**WHITE LAKE TOWNSHIP
INTER-OFFICE MEMORANDUM
COMMUNITY DEVELOPMENT DEPARTMENT**

**SUBJECT: Culver's
Preliminary site plan approval**
Property described as parcel number 12-20-276-035, located on the north side of Highland Road (M-59) and west of Bogie Lake Road, with a project area on the parcel consisting of approximately 1.69 acres, currently zoned (PB) Planned Business District.

RE: Culver's- Preliminary Site Plan Review – 2nd Review

RE: Culver's
Preliminary Site Plan – Review #2

PHASE: P. SPA
 JOB NO.: 230601
 CIVIL ENGINEERING · LAND SURVEYING
 SITE PLANNING
 C301

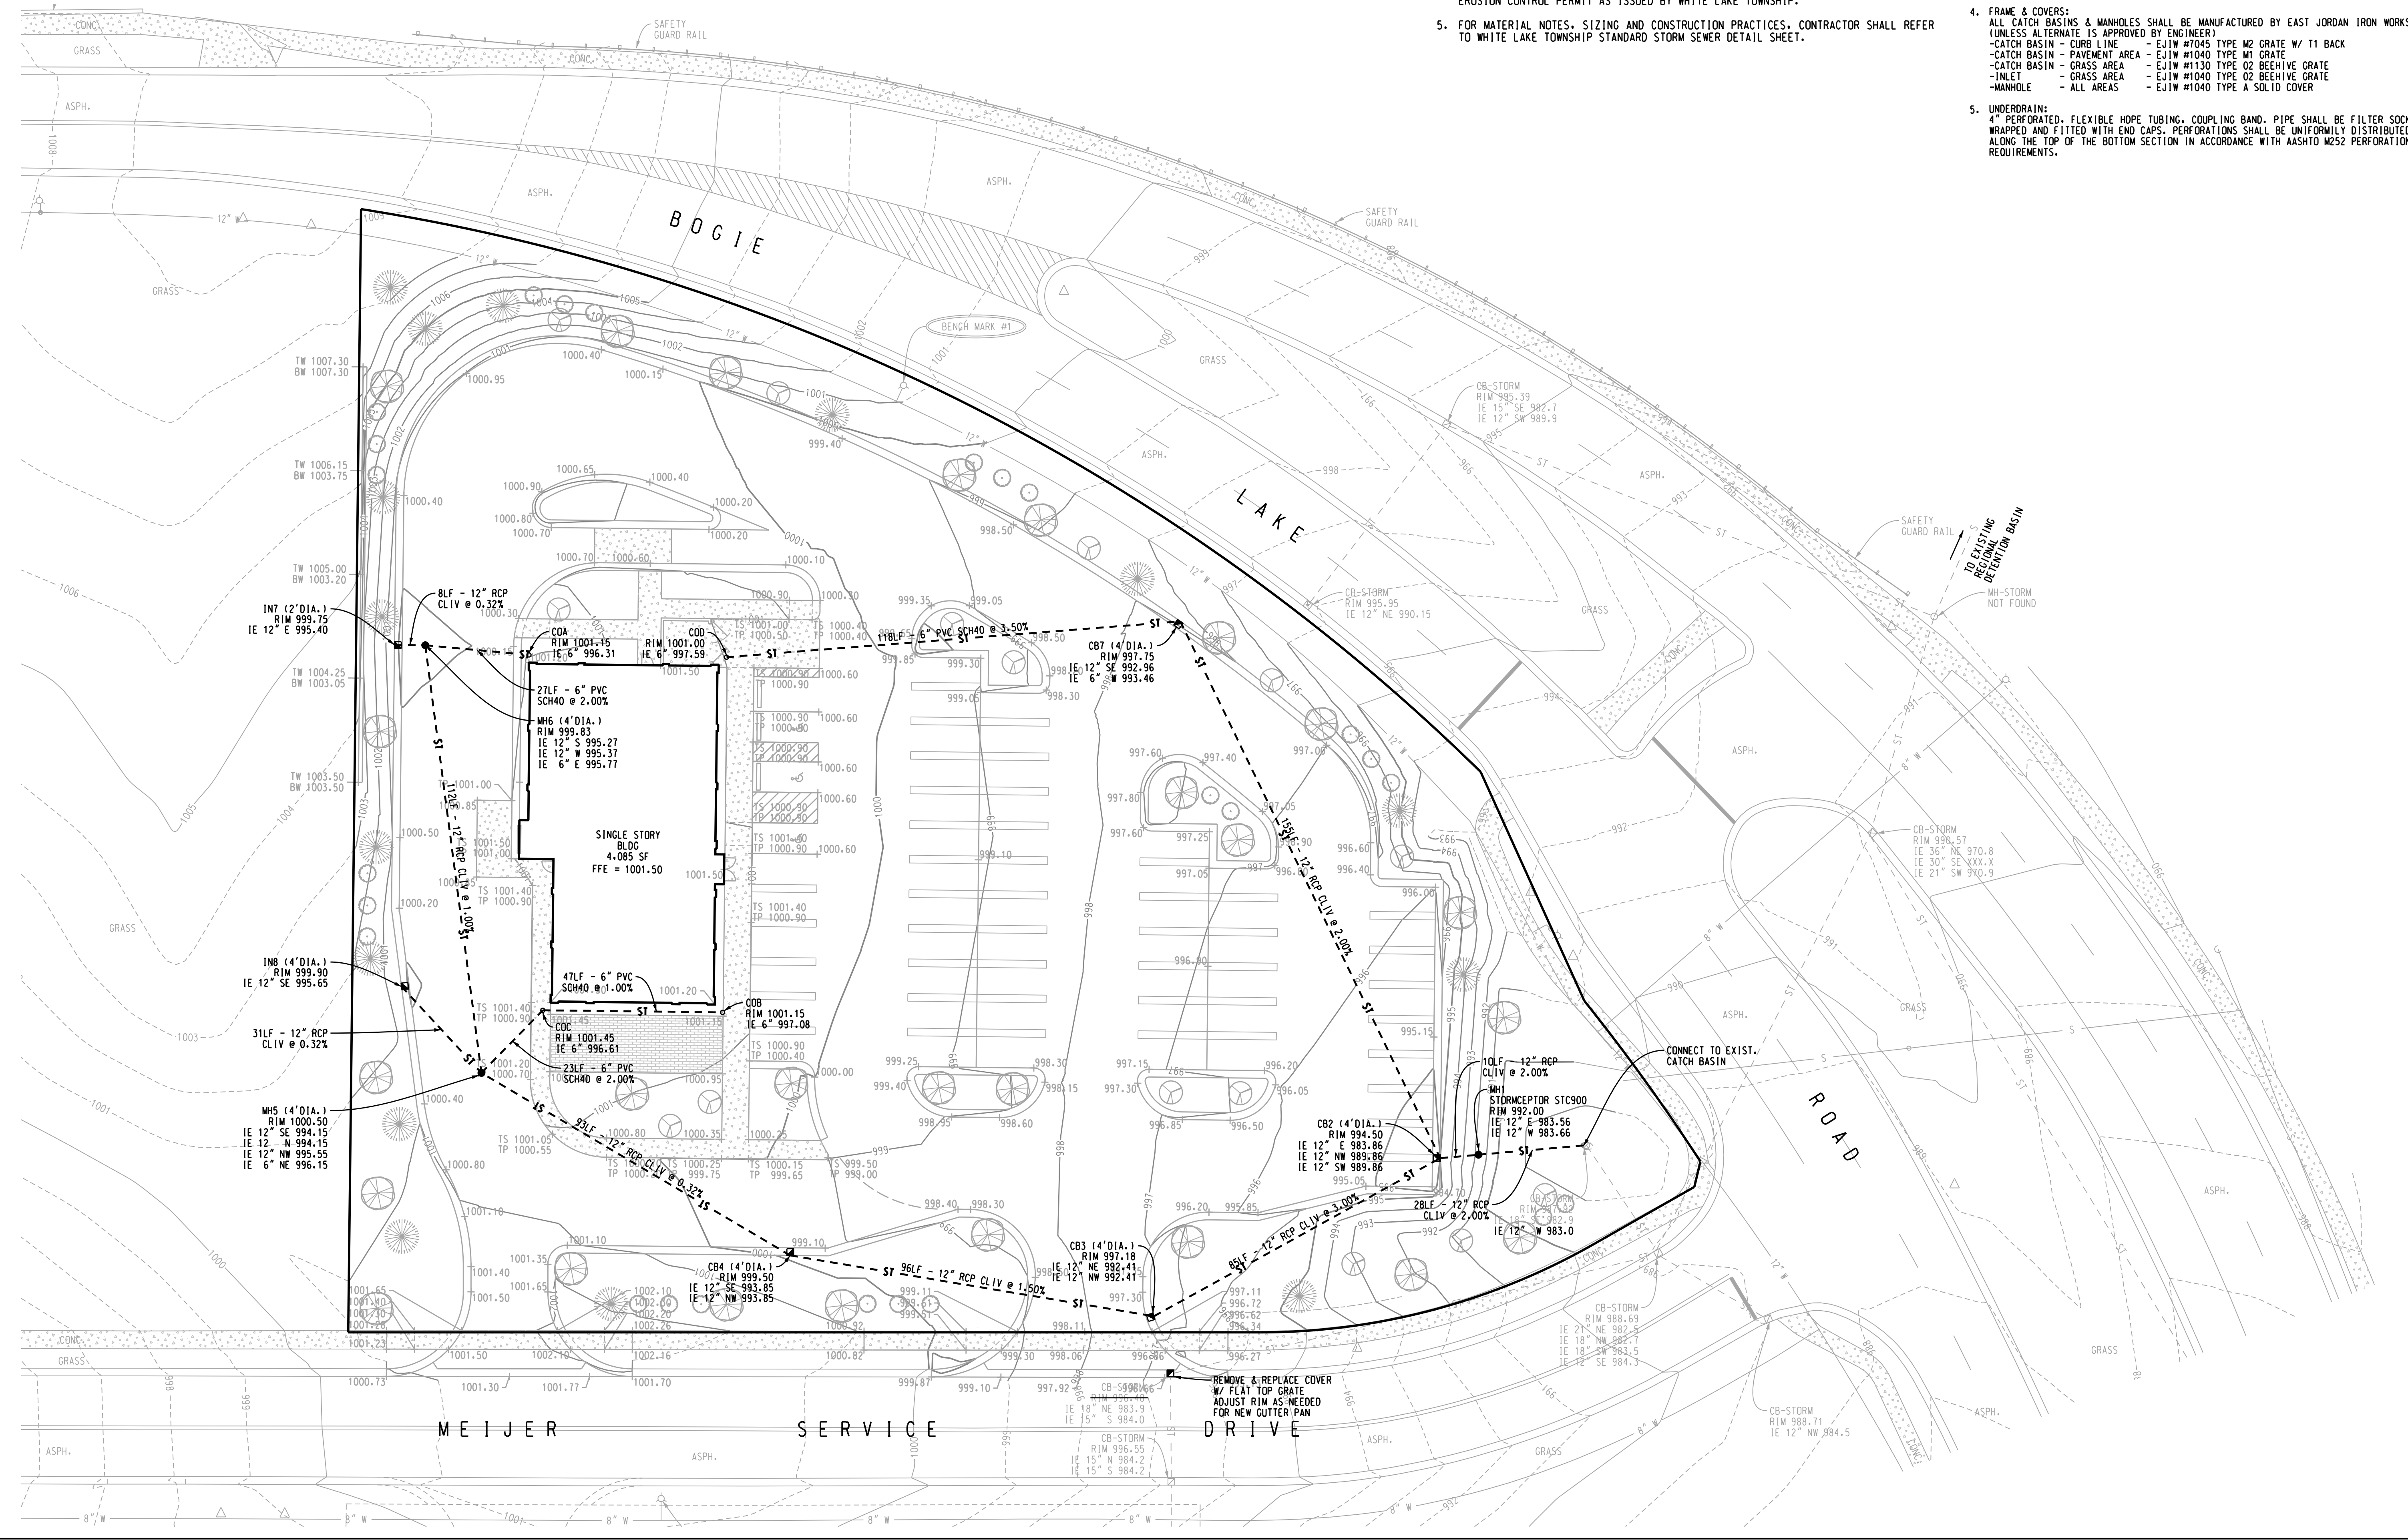
- p) *Sheet C301- Based on the existing storm sewer invert (per Meijer storm sewer as built plan) for EX1 of 984.85, storm drainage would back up in proposed Stormceptor (MH1) and remainder of proposed pipe (CB2 -EX1) and into CB2. Please review and revise, including storm sewer calculations, as necessary. In addition, please reference comment e) above. Comment addressed, grades were confirmed by surveyor and positive drainage is anticipated.*

- q) *Sheet C301-The proposed storm sewer is too close to the proposed retaining wall. Please shift sewer further to the east. Comment addressed. Storm sewer layout has been revised such that storm sewer is now shifted away from proposed retaining wall.*

SITE UTILITY PLAN

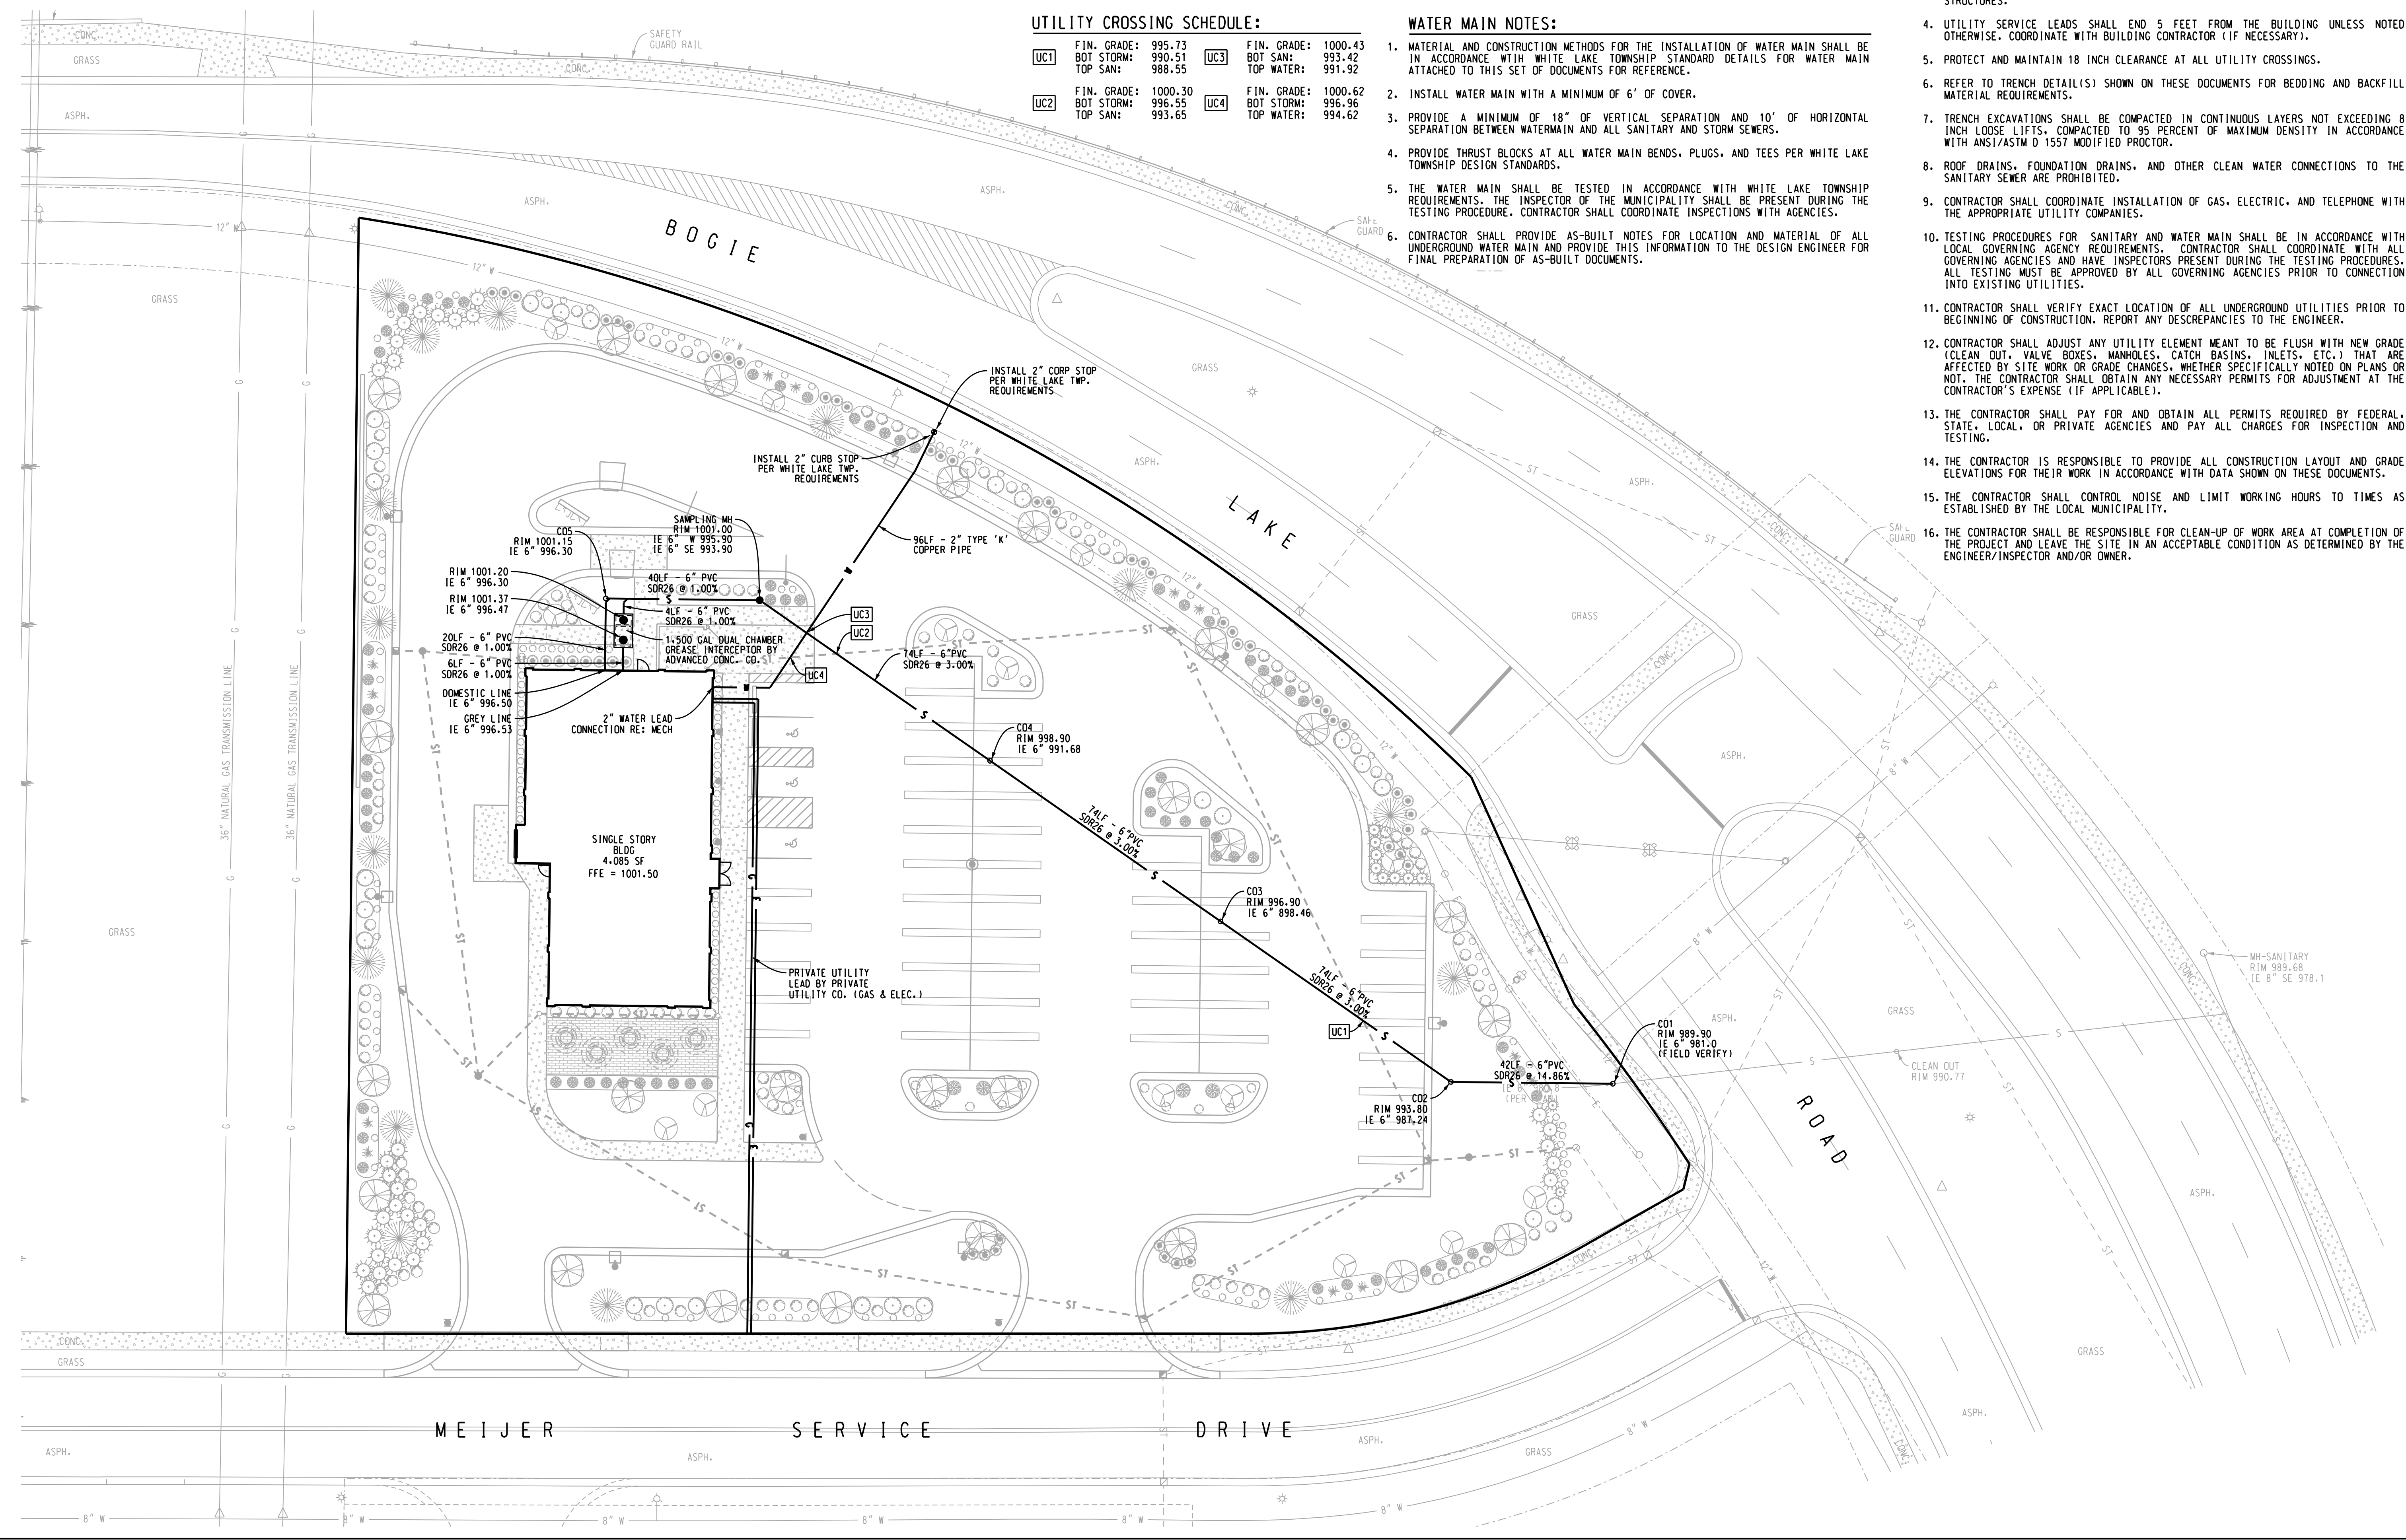
- r) *Sheet C400-The proposed sanitary sewer pipe diameter shall be required to be 8" diameter (8" required if pipe length > 150'). Comment addressed. 6" lead will suffice based on conversation with our office.*

- s) *Sheet C400- The proposed sanitary sewer lead will be required to be lowered at water service crossing UC3 to achieve the minimum required 18" vertical pipe separation. Comment addressed. The water lead has been lowered and placed a minimum of 18" vertical separation under the sanitary lead.*
